City of Santa Fe, New Mexico

memo

2025-010873-HDRB, 219 and 219 A Washington Ave, Downtown & Eastside Historic District, Contributing, Robert Evans, agent for Dennis Price, owner, requests approval for a 640 sq. ft. addition including a two-story structure to a height of 19'-8" at 219 Washington Ave and construct a new 1,580 sq. ft. two-story structure at 219 A Washington Ave to a height of 23'-0" where the max allowable is 20'-1". Exceptions are requested to 14-5.2(D)(2)(d) an addition shall not exceed fifty percent of the square footage of the existing footprint and 14-5.2(D)(9) height.

Figure 5. Proposed 219 Washington Ave West Elevation.

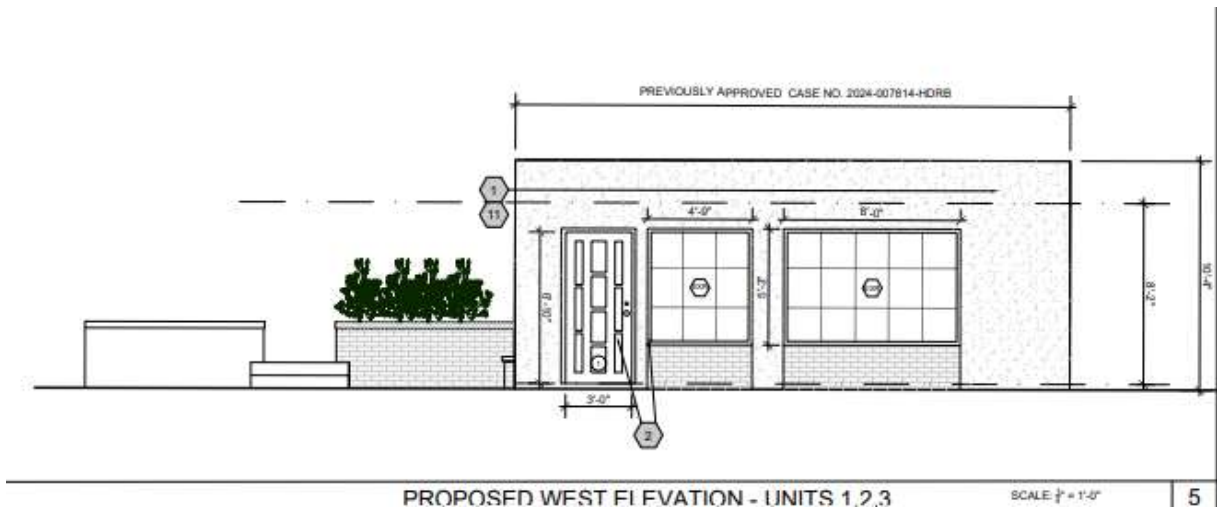
The addition of a Territorial Revival parapet with a brick coping to the existing historic garage structure creates a false sense of history for this historically contributing building. So as to not threaten the contributing status of the building, no brick coping should be added to the existing historic structure. The proposed additions may have a brick coping.

Figure 7. Proposed 219 A Washington Ave West Elevation.

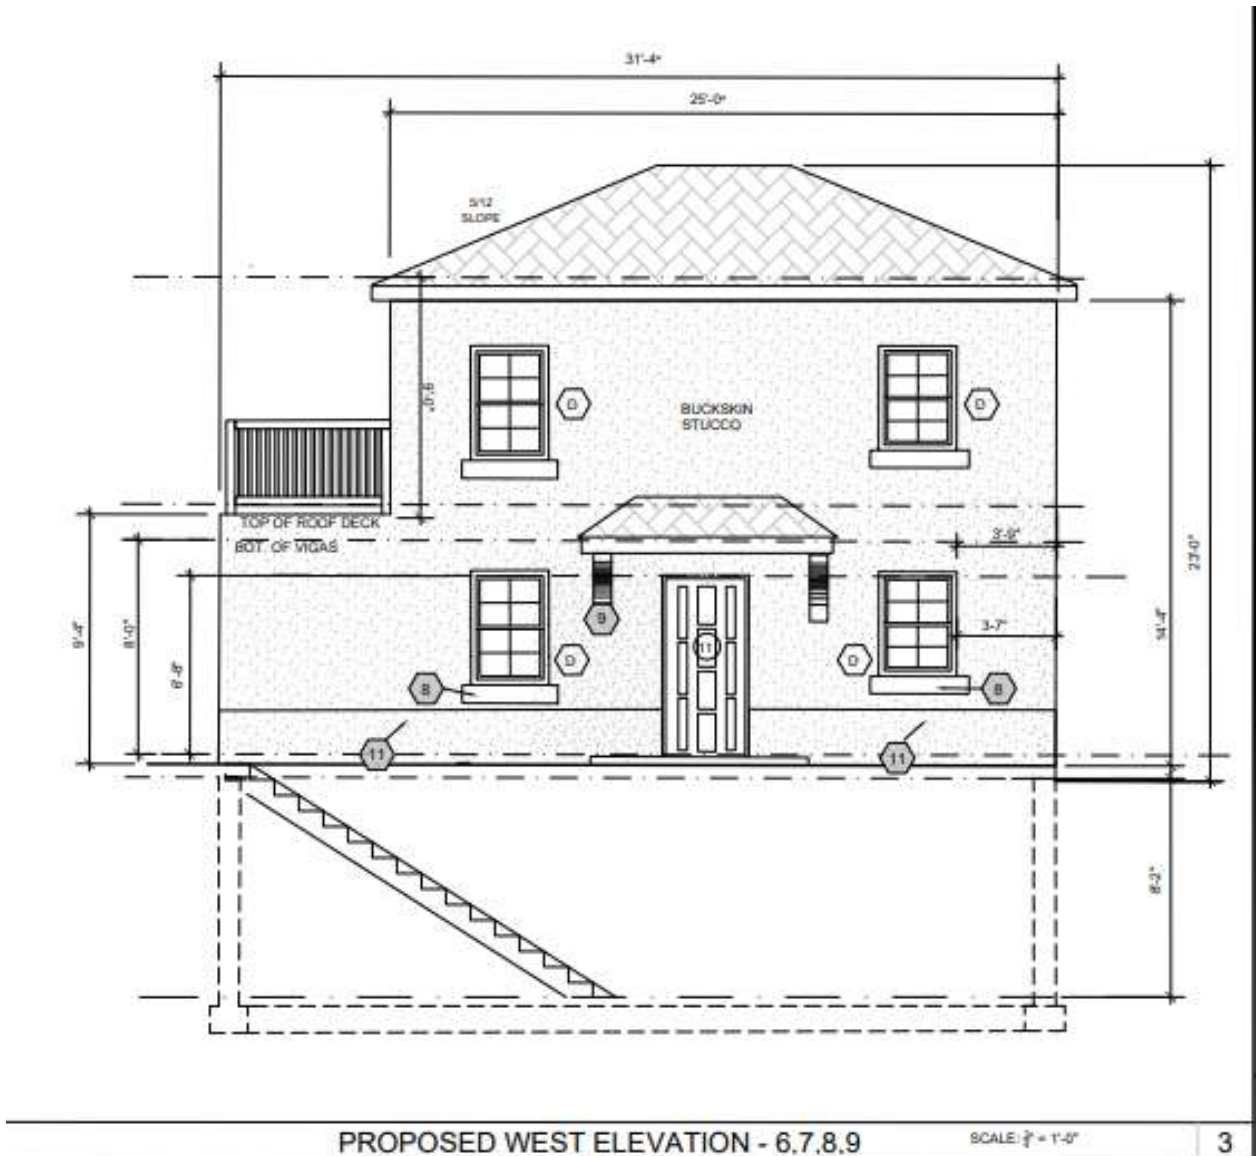
Staff Response: Staff has evaluated the applicant's response and finds that the criterion has been met. The proposed height of 23'-0" at (219A) is greater than the maximum allowable height of 20'-1" by 2'-11". The adjacent two-story building at 215 Washington Ave is currently 29'-8" high. The variation of the proposed (219A) will be 6'-8" shorter than (215) which will provide less of a visual impact on the streetscape and will not impact the contributing structures in the vicinity adversely.

Staff Response: Staff has evaluated the applicant's response and finds that the criterion has been met. The proposed height of 19'-8" at (219) and 23'-0" at (219A) is greater than the maximum allowable height of 20'-1" by 2'-11" respectively, however is 6' shorter than the adjacent two-story building at 215 Washington Ave. The variation of the proposed (219A) will
